94
Do objection
letter
TAC

The following comments are in response to Mountain Cement Company's submission for public notice their proposal to mine Amendment 298C-A7 of mine permit 298c

Figure 2 Air photograph of the Area "C" mine area and Etchepare 7a showing fractures in the mining areas.

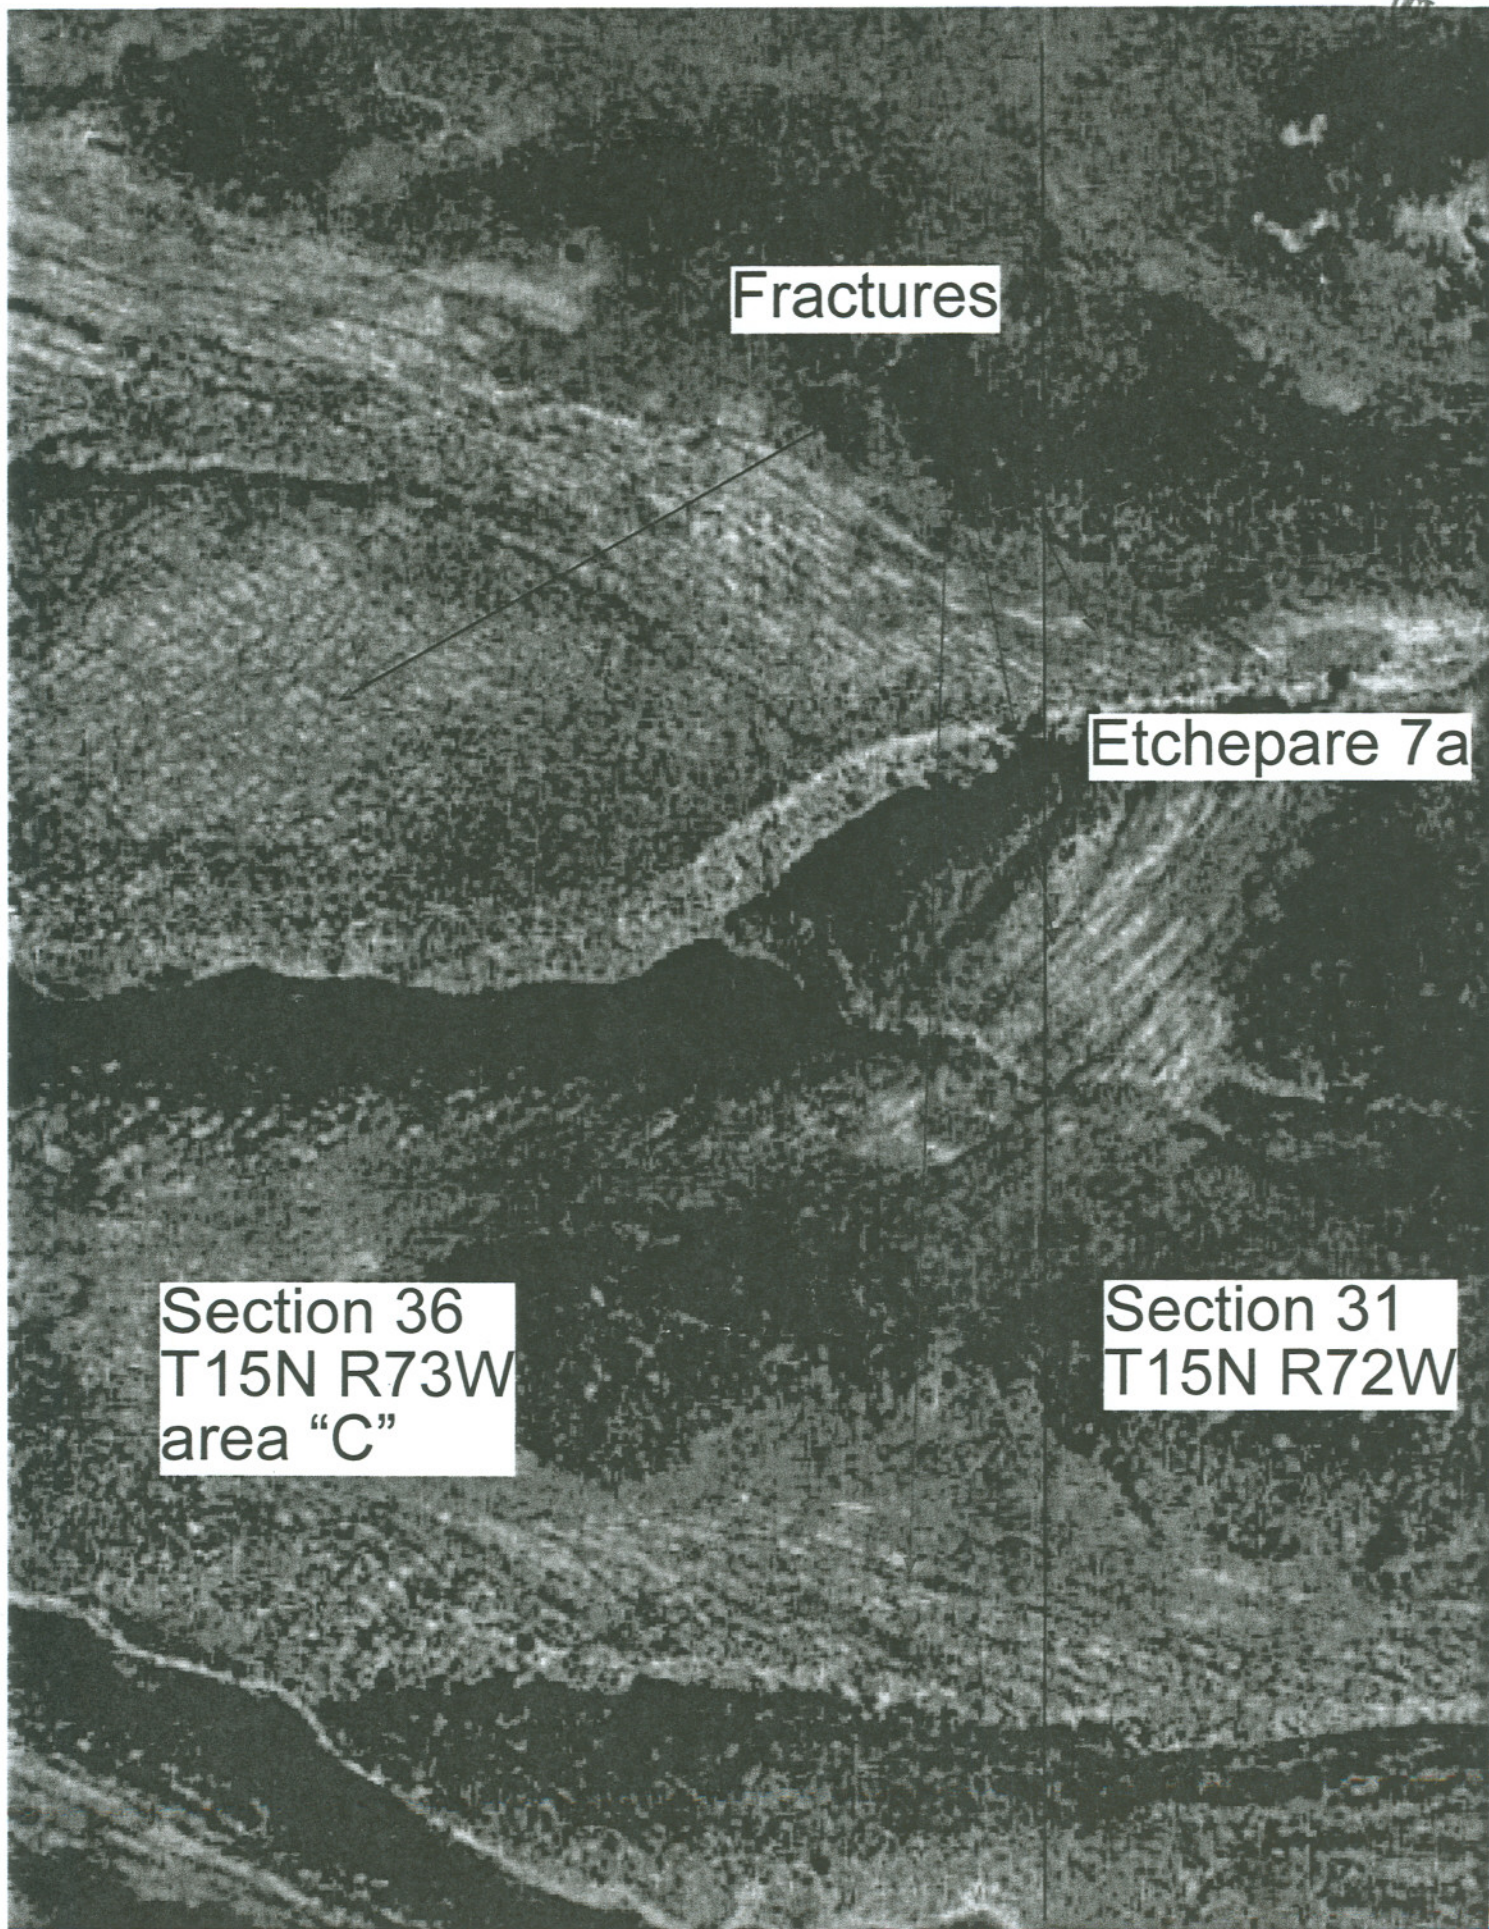
4. It is stated on Page DVIII5-3 that *"Several faults have been identified along the western flank of the Laramie Range in the Etchepare amendment; however, none have been identified in the proposed limestone expansion permit"*. Though no faults are known for the proposed project area, there does not appear to be any discussion on the series of northeast-south and the northwest-southeast trending fractures in this area. These fractures range up to ± 30 inches wide in the adjacent Etchepare quarry with some fractures surfically filled with sand and others completely open after removal of the rock overburden. Who did the geological survey for this area after discovery of the extensive fracturing of this area became known?
